Montagehinweis

Leiterplatte Steuerung - Maestro 4S - Art.-Nr. 8936937

Ausgabe: 01/2016 · Art.-Nr.: 9009851

PCB Control - Maestro 4S - Part. No. 8936937

Leiterplatte Steuerung

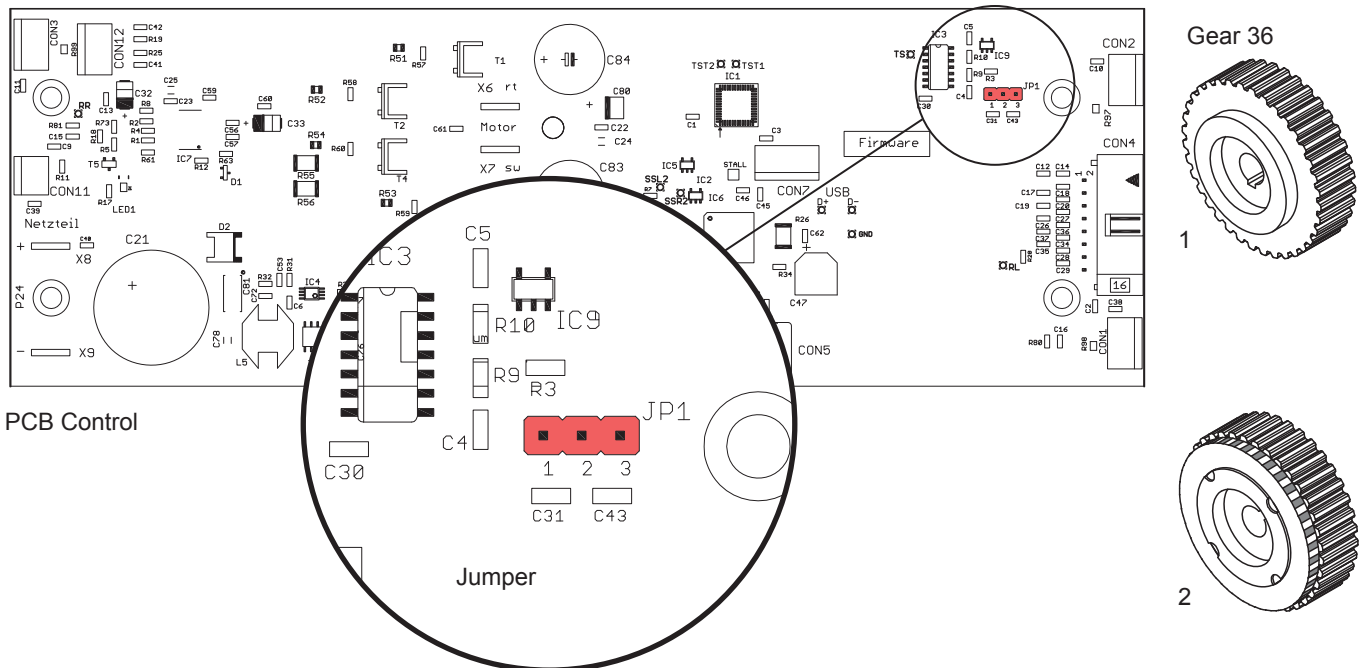
Ab der Seriennummer 4375 wurde der Nutzentrenner MAESTRO 4S mit einer neuen Riemenscheibe versehen, welche eine kontrastreichere Taktscheibe aufweist.

Um die Leiterplatte Steuerung in Geräten vor und nach der Seriennummer 4375 nach einem Tausch betreiben zu können, ist es notwendig mittels Jumper eine Anpassung vorzunehmen.

From serial number 4375 was mounted a new gear with a high-contrast into the PCB separator MAESTRO 4S.
To use the PCB Control in devices to and from serial number 4375 it's necessary to set a jumper.

Seriennummer	Riemenrad	Jumper als Brücke auf
bis 4374	1	1 und 2
ab 4375	2	2 und 3

Serial number	Gear type	Jumper as bridge between
to 4374	1	1 und 2
from 4375	2	2 und 3
